CONSIDER AN APPLICATION FOR SPECIAL USE PERMIT MODIFICATION CHAPEL HILL HIGH SCHOOL, 1709 HIGH SCHOOL ROAD (PROJECT #17-059)

STAFF REPORT SERVICES

TOWN OF CHAPEL HILL PLANNING AND DEVELOPMENT

PROPERTY ADDRESS 1709 High School Road	DATE February 27, 2018	APPLICANT Chapel Hill Carrboro City School
--	----------------------------------	--

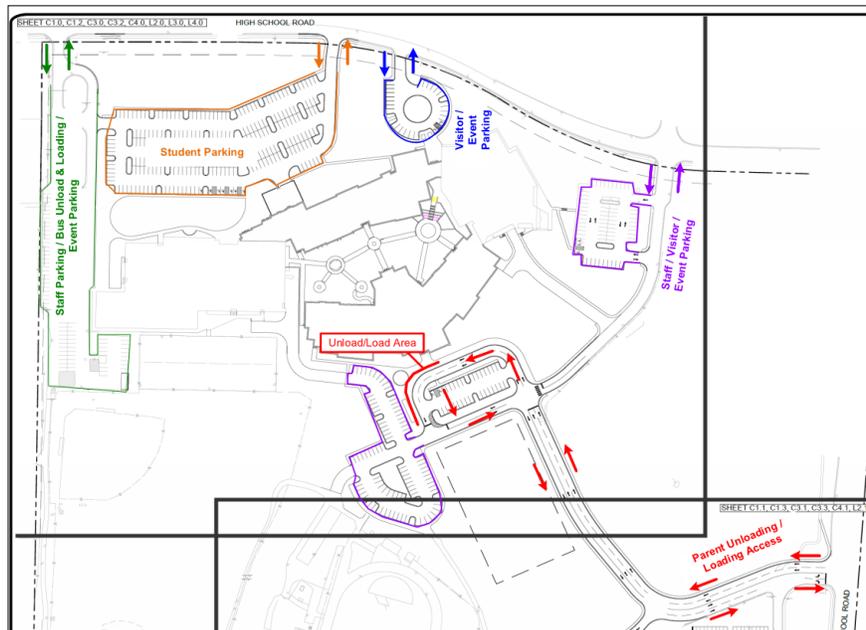
Access (from left to right)	Purpose
High School Rd Access #1 (shown in green)	Bus Unloading/Loading, Staff Parking
High School Rd Access #2 (shown in orange)	Student Parking
High School Rd Access #3 (shown in blue)	Visitor Parking
High School Rd Access #4 (shown in purple)	Staff/Visitor Parking
Seawell School Road Access #5 (shown in red)	Student Drop-off & Pickup, Staff/Visitor Parking

Note: The site orientation in the graphic above has since been modified although the purposes of the highlighted parking lots and accesses remain the same.
